August 17, 2012 (Revised September 20, 2012)

Subject: CSO160 Sewer Separation
Project Modification
IOAP Project No. L_OR_MF_160_S_08_A_A_0
DOJ Case No. 90-5-1-1-08254

MSD is requesting approval of a proposed minor project modification to the CSO160 Sewer Separation project (IOAP Project No. L_OR_MF_160_S_08_A_A_0). This modification is part of an overall adaptive management review of the approved 2009 IOAP that will be documented in the proposed 2012 IOAP Modification to be formally submitted in 2013. Since the project modifications will affect MSD's implementation activities prior formal submittal of the revision documentation, approval of the proposed modification is requested at this time.

Ohio River
Solution ID # L_OR_MF_160_S_08_A_A
CSO160 Sewer Separation

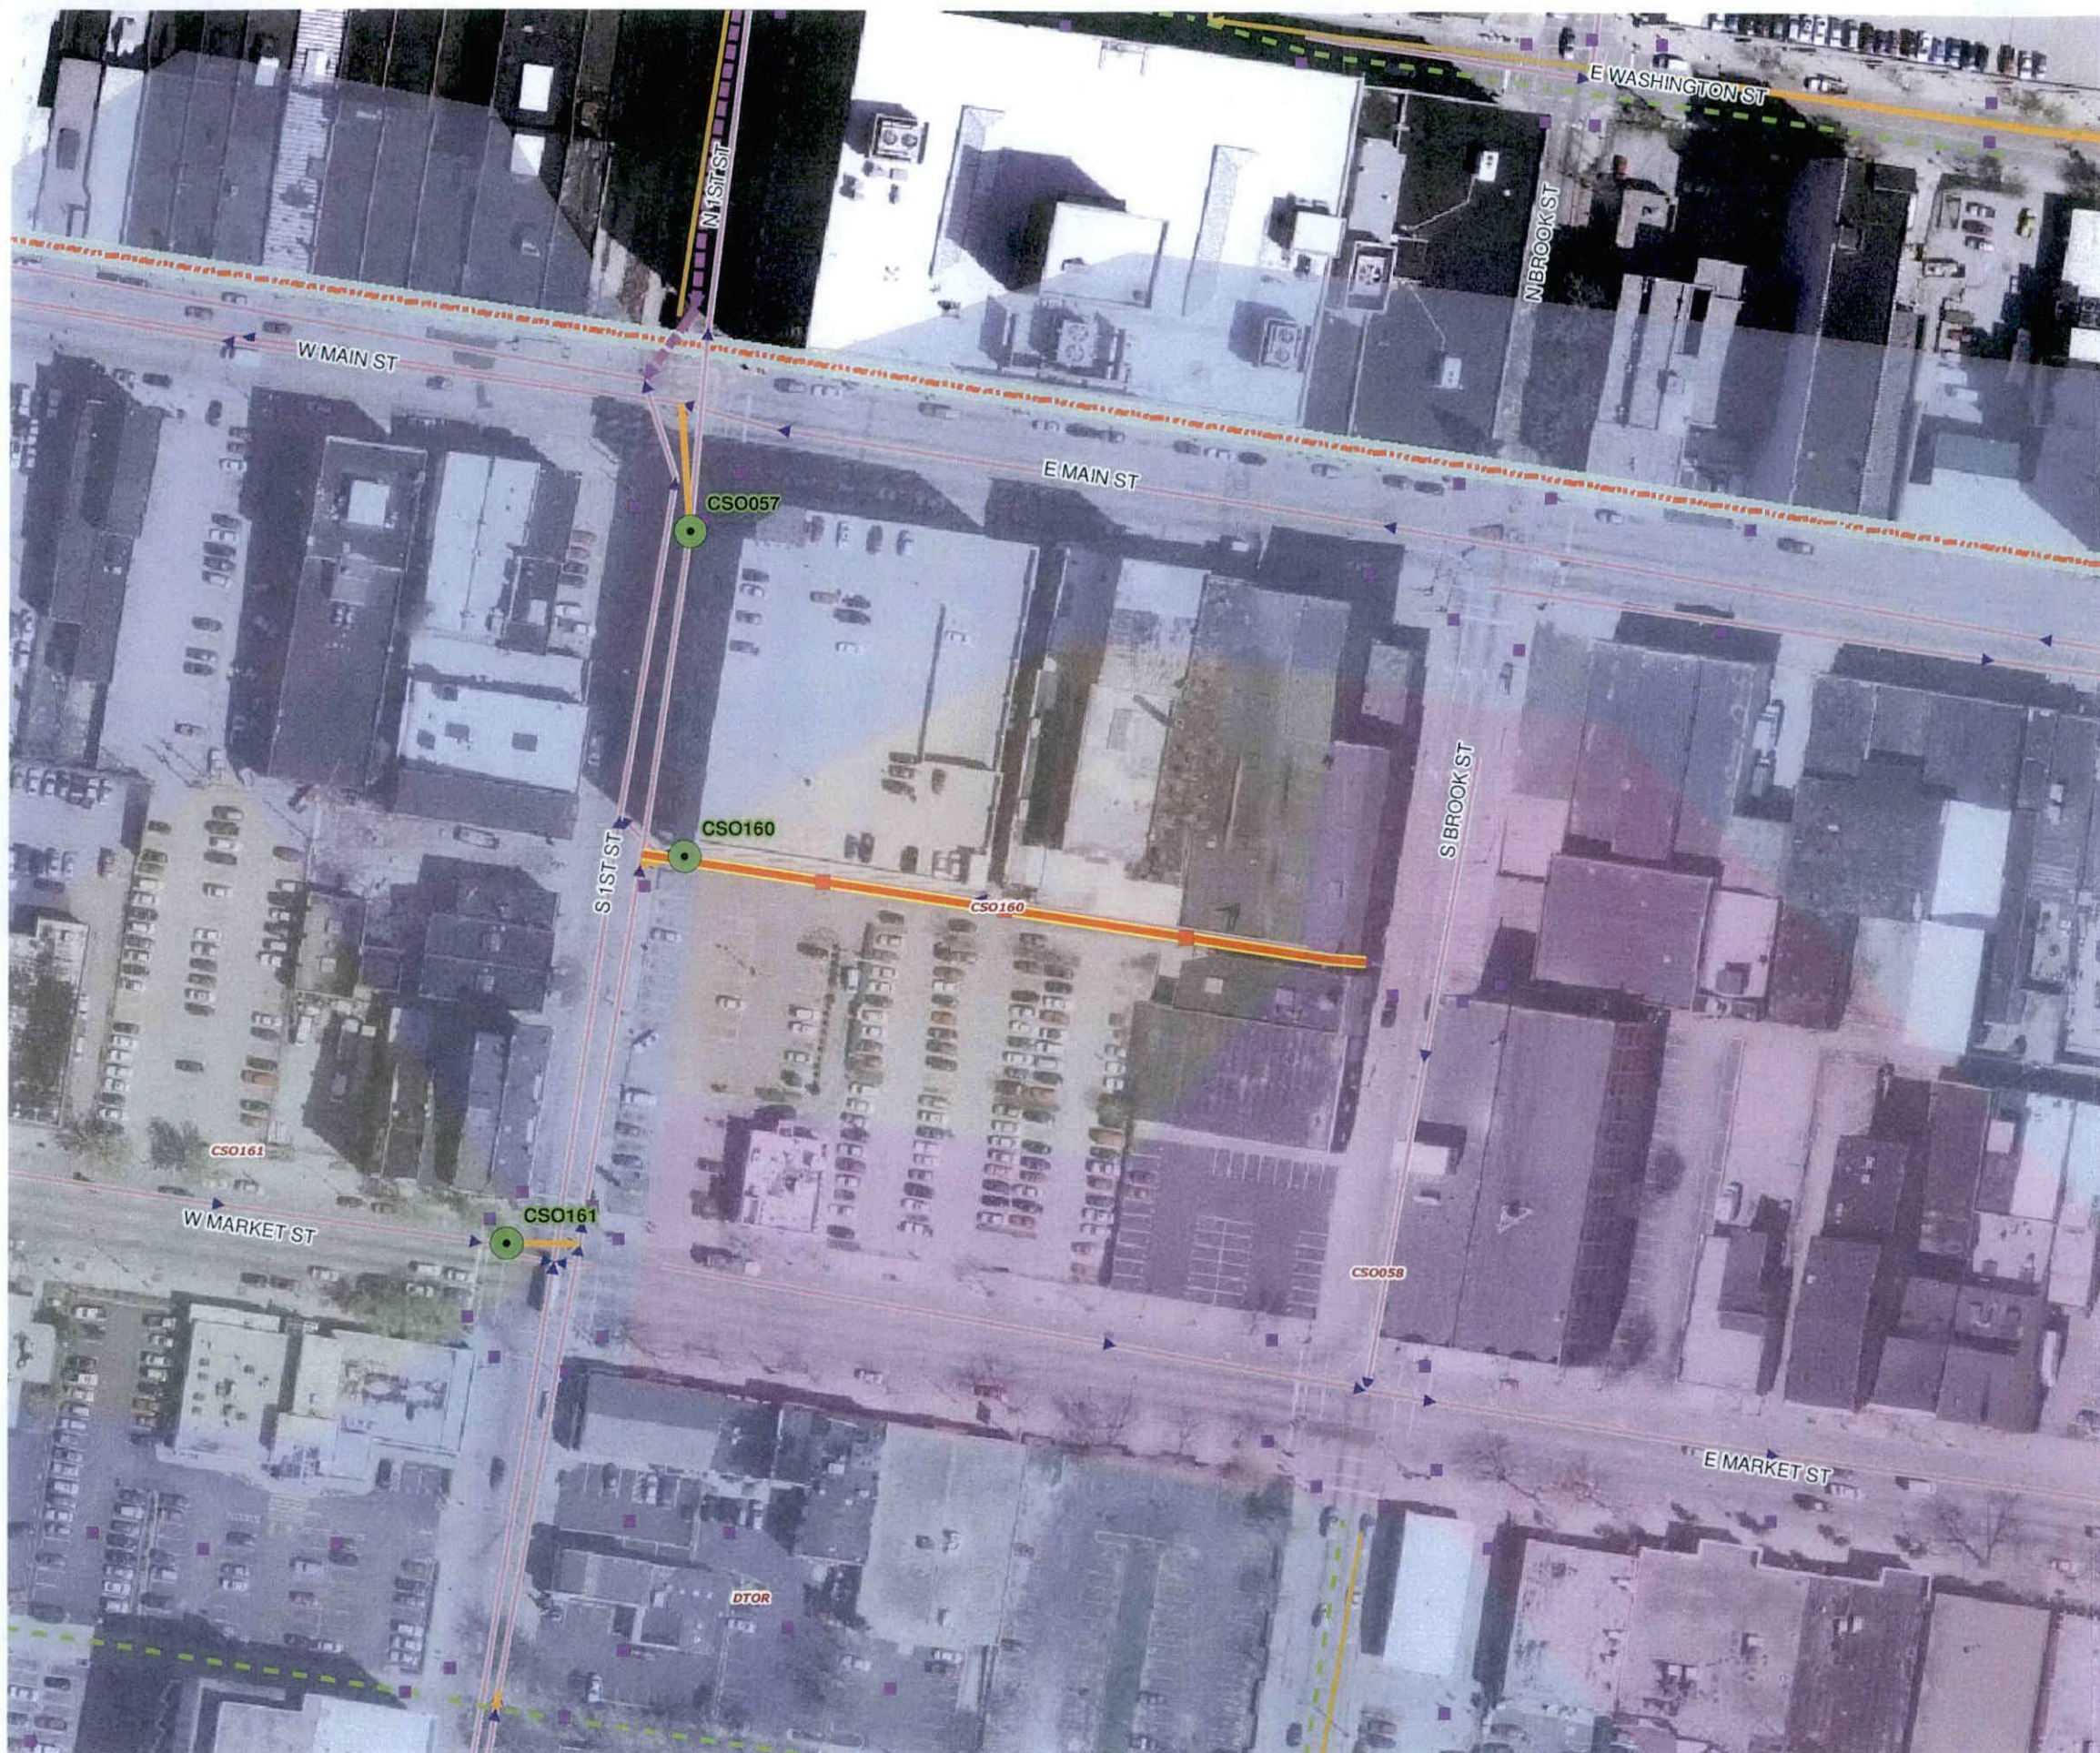
The original CSO160 Sewer Separation project included the separation of 425 linear feet of combined sewer line, with a completion date of December 31, 2015.

The project modification involves the creation of in-line storage provided by a combination of raising the existing overflow weir and installing 88 feet of 72-inch diameter pipe. Based on benefit/cost analysis, the level of control will remain at zero CSO events in a typical year. Note also that the original sewer separation project would have allowed "first flush" urban stormwater runoff to reach the Waters of the US with virtually every rain event. It is likely that capturing first flush stormwater runoff represents an

Further investigation indicated that in-line storage can be provided by a combination of raising the existing weir and installing 88 feet of 72-inch diameter pipe. This proves to be a more cost effective alternative to mitigate the overflows at CSO160 in comparison to completing a full CSO separation project. This solution also provides the best benefit/cost ratio.
